FINAL CONSTRUCTION PLANS

BROOKWILLOW VILLAGE

CITY OF GRAND JUNCTION, COLORADO

REVISED PER CITY SEWER DESIGN 1-20-06
REVISED PER CITY OF GRAND JUNCTION COMMENTS 12-22-05
CITY OF GRAND JUNCTION COMMENTS 11-15-05
CITY OF GRAND JUNCTION COMMENTS 8-19-05
DRAWING NO. 1 OF 45 — 2005-145 — 8/19/05 — T1-BROOKWILLOW

PPSS-4

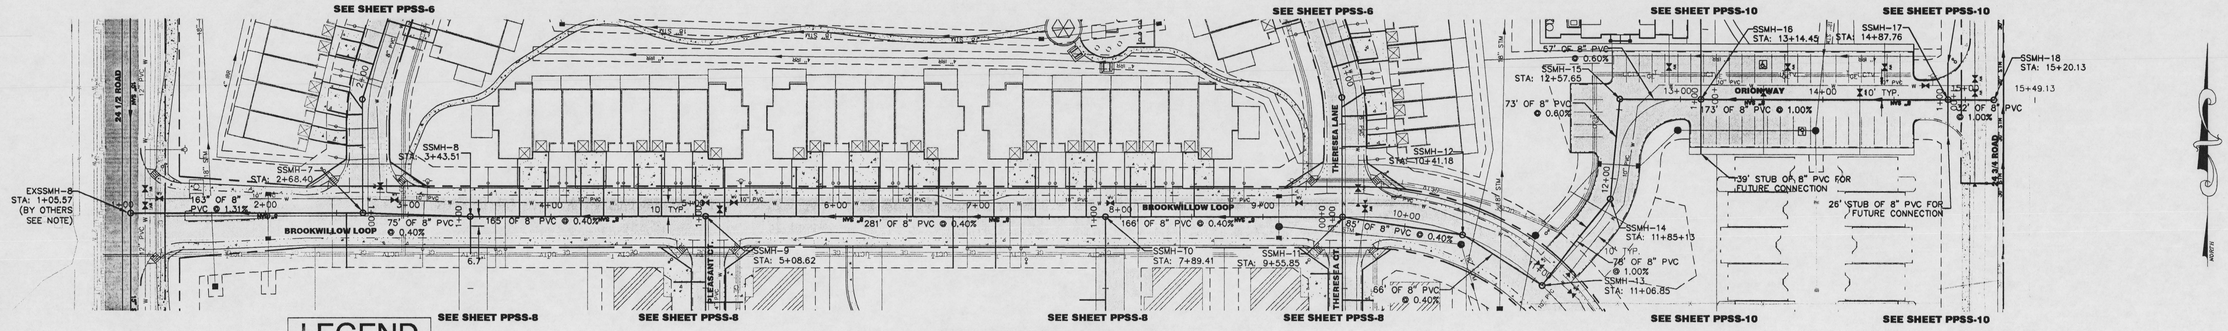
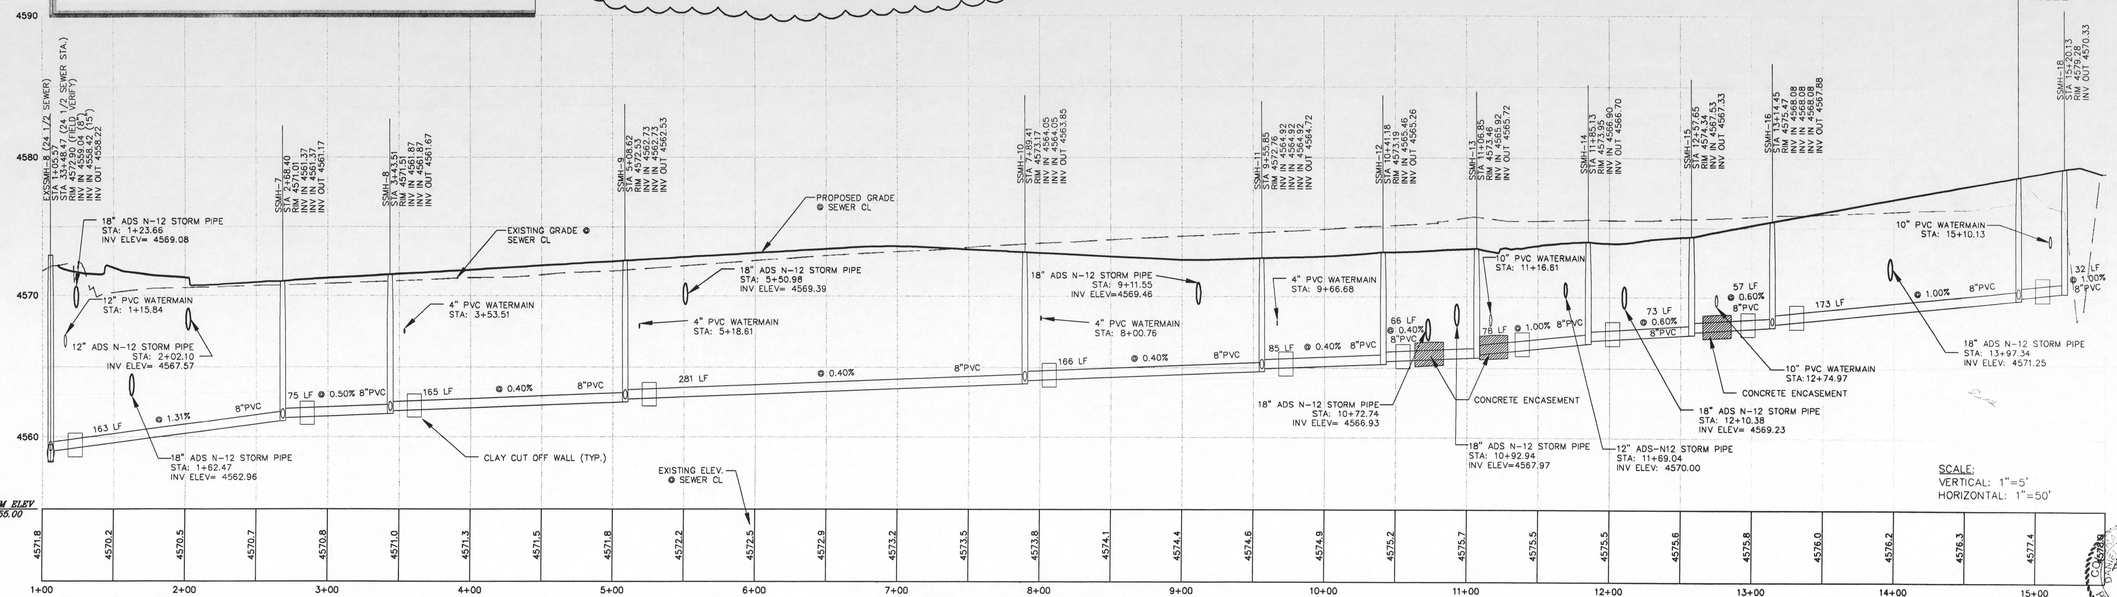
13.) REVISIONS THIS SHEET INCLUDE SHALLOWING THE ENTIRE SANITARY SEWER MAIN.

PPSS-6

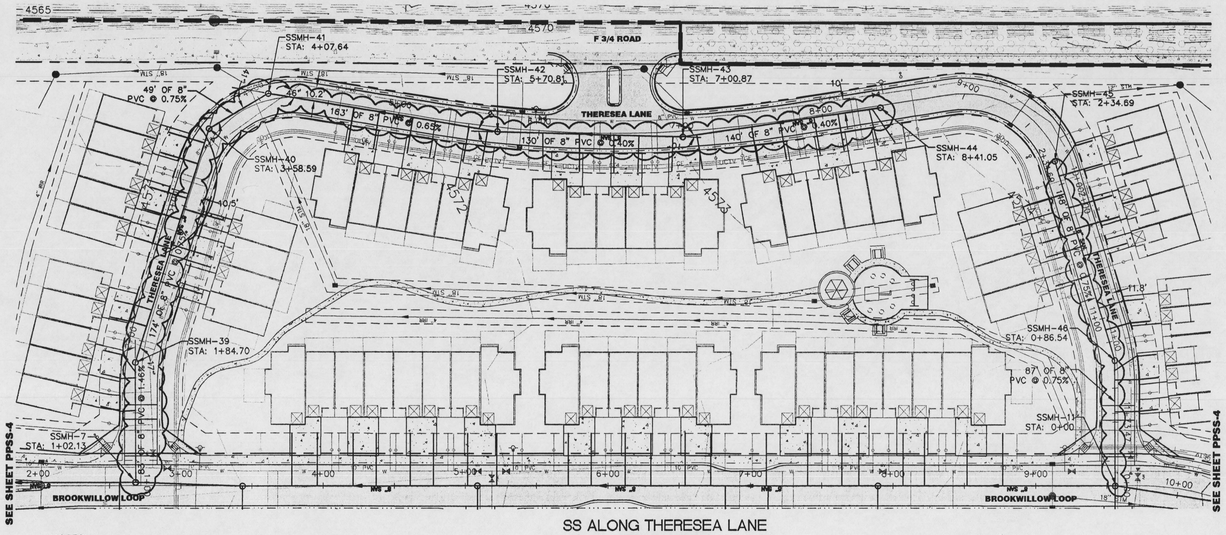
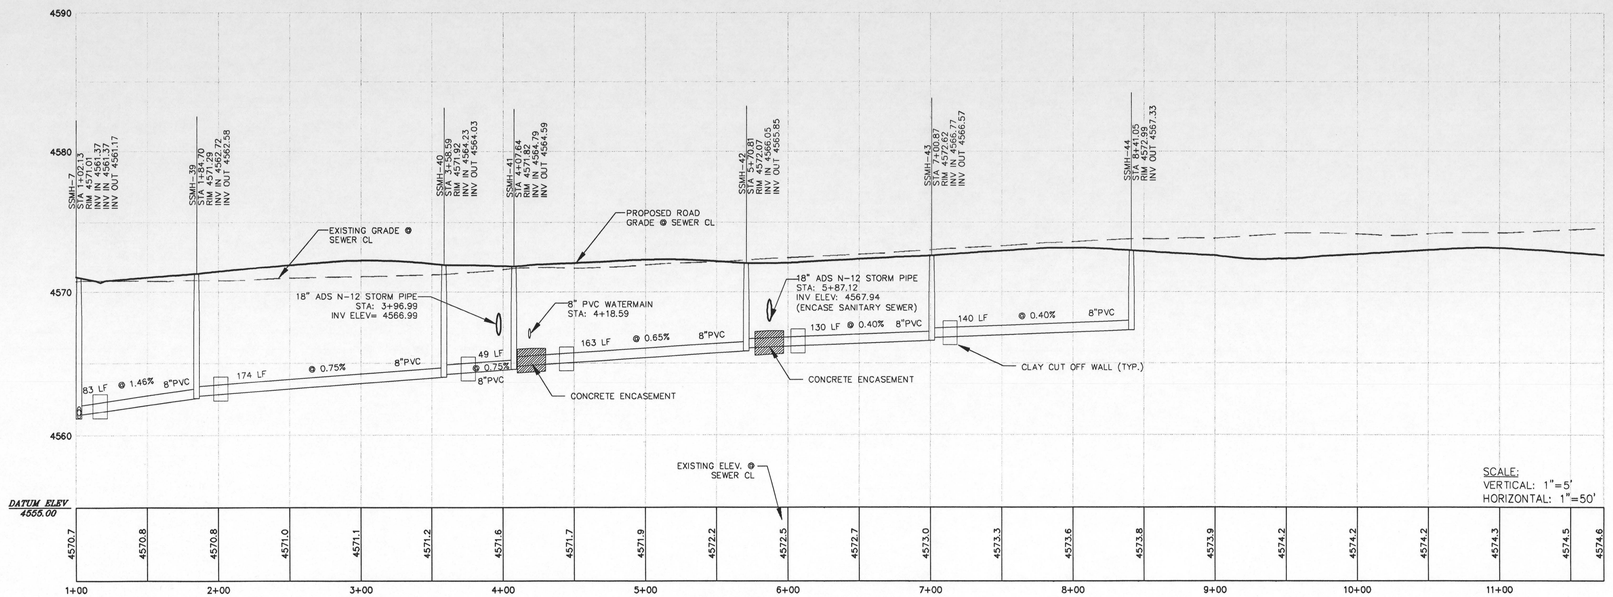
13.) REVISIONS THIS SHEET INCLUDE SHALLOWING THE ENTIRE SANITARY SEWER MAIN.

REVISION FOR THIS SHEET: SHALLOWED SANITARY SEWER LINE.

BROOKWILLOW VILLAGE
CUL-DE-SACS SANITARY PLAN & PROFILES STA: 1+00 TO END

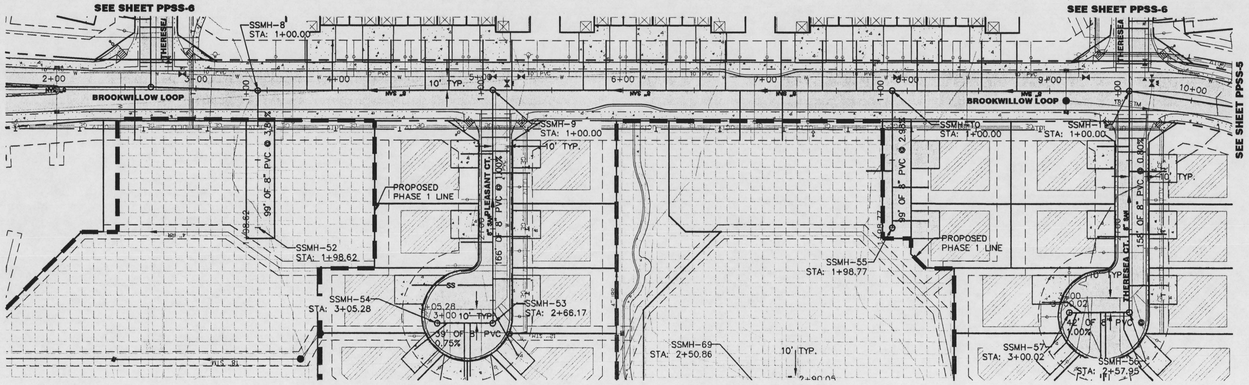
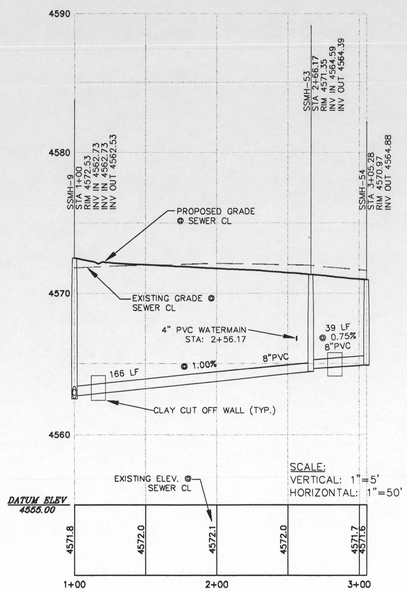
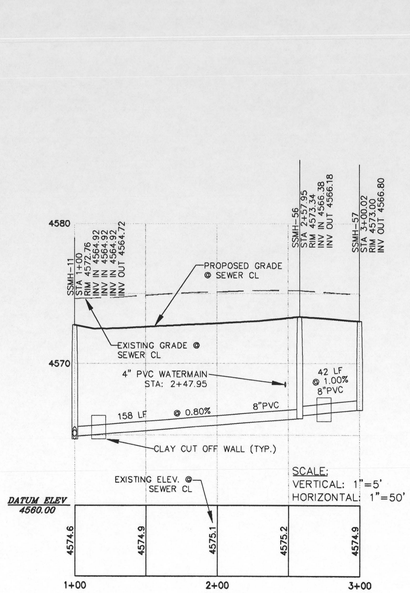
13.) REVISIONS THIS SHEET INCLUDE SHALLOWNG THE ENTIRE SANITARY SEWER MAIN.

NOTE REVISION FOR THIS SHEET:
ALL SANITARY SEWER MAINS SHOWN WERE MADE SHALLOWER AND SLOPES STEEPENED

PPSS-10

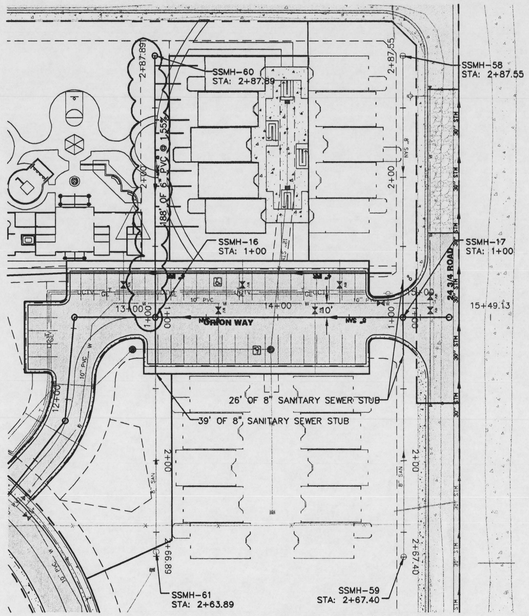
13.) REVISIONS THIS SHEET INCLUDE SHALLOWING THE ENTIRE SANITARY SEWER MAIN.

NOTE REVISION FOR THIS SHEET:
ALL SANITARY SEWER MAINS SHOWN WERE MADE SHALLOWER AND SLOPES STEEPENED

BROOKWILLOW VILLAGE STORM SEWER PLAN & PROFILE STA: 1+00 TO STA: 12+00

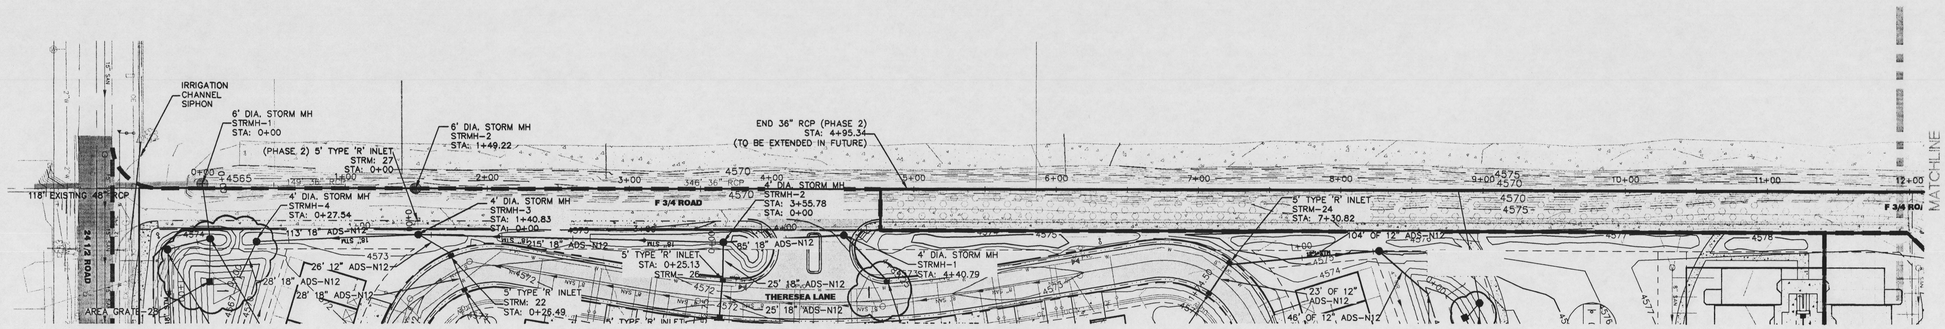
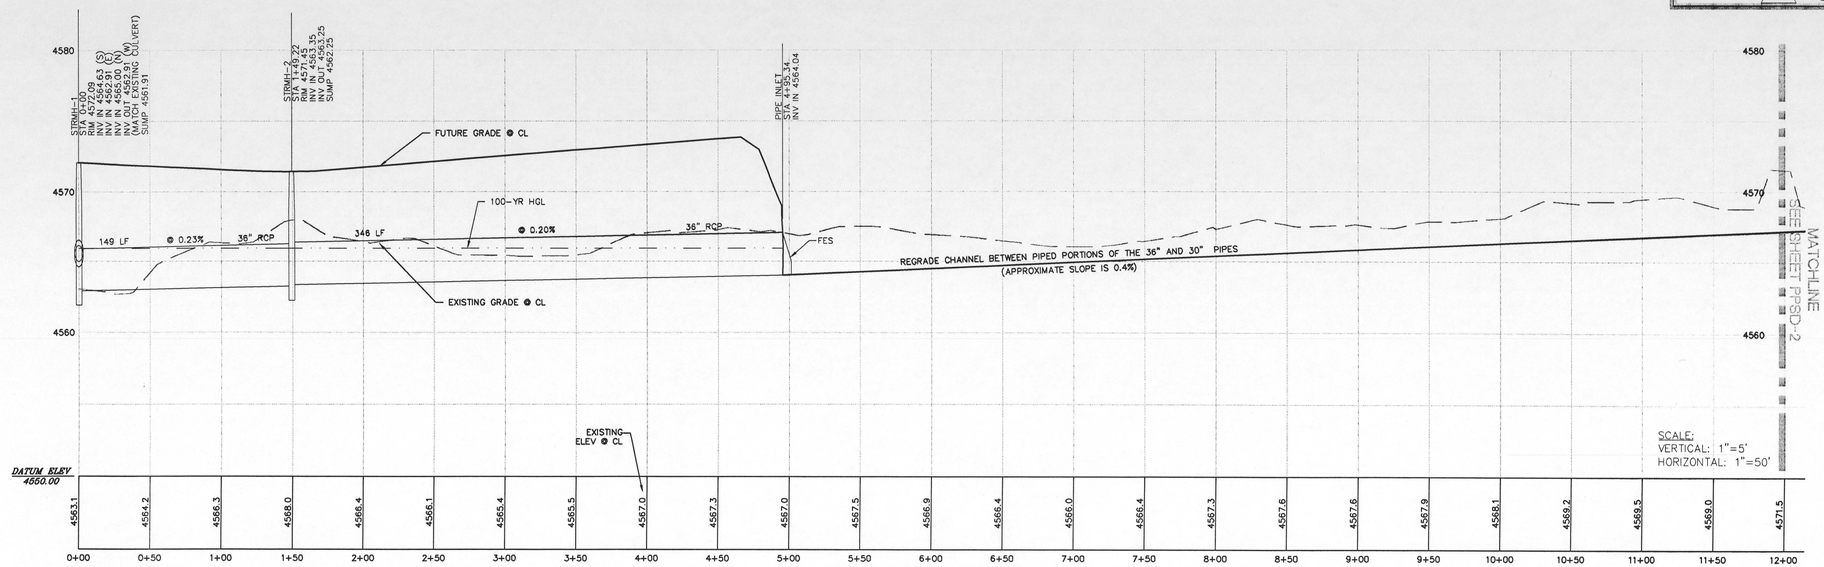
REVISIONS
1. MOVED LOCATION OF INLET
2. MOVED OUTLET STRUCTURE AND GRADED SPILLWAY

PPSD-6

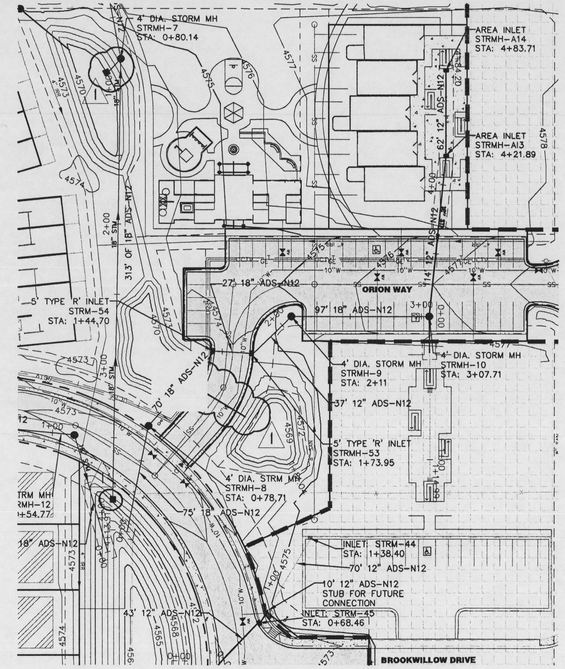
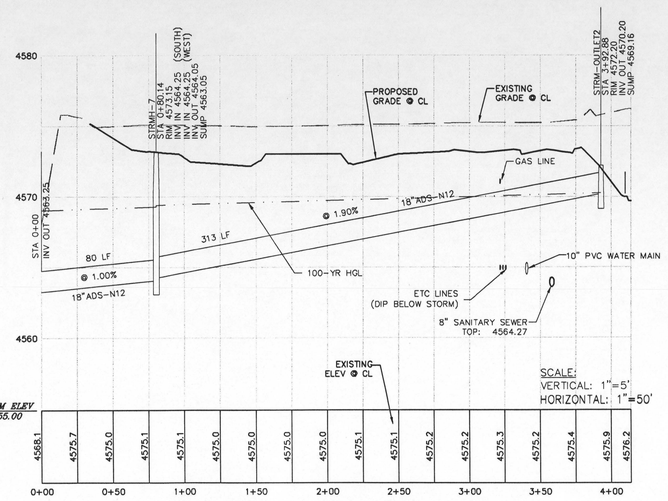
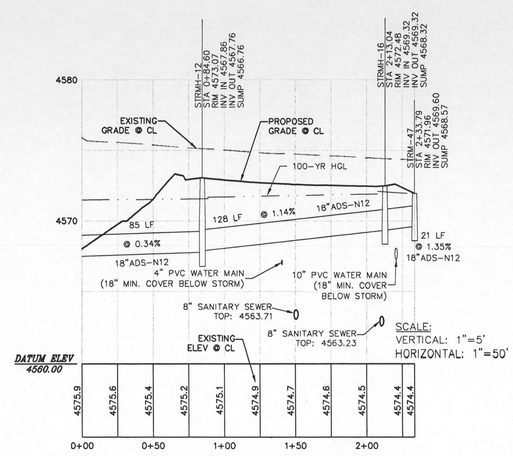
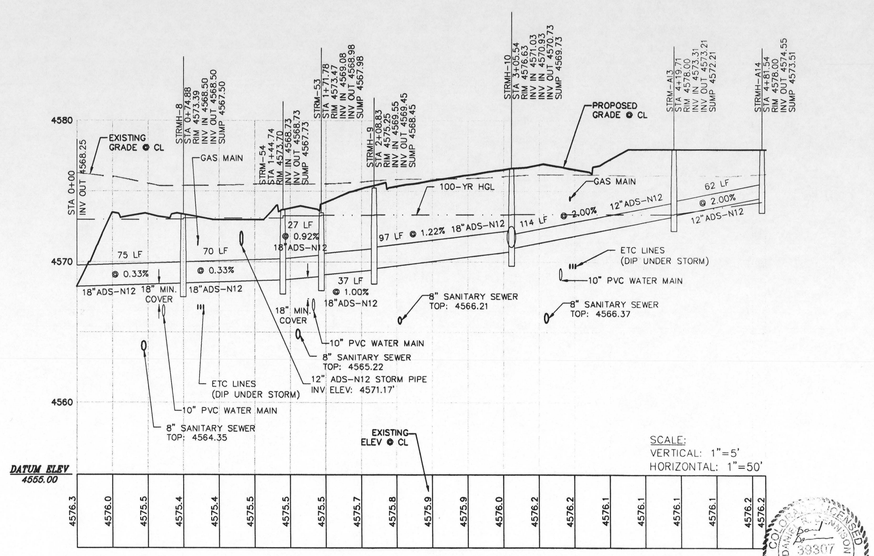
1. REMOVED BOX CULVERT AND REPLACED WT H12" ADS-N12 PIPE.
2. CHANGED OUTLET STRUCTURE LOCATIONS.
3. CHANGED ALIGNMENT OF STORM PIPE.
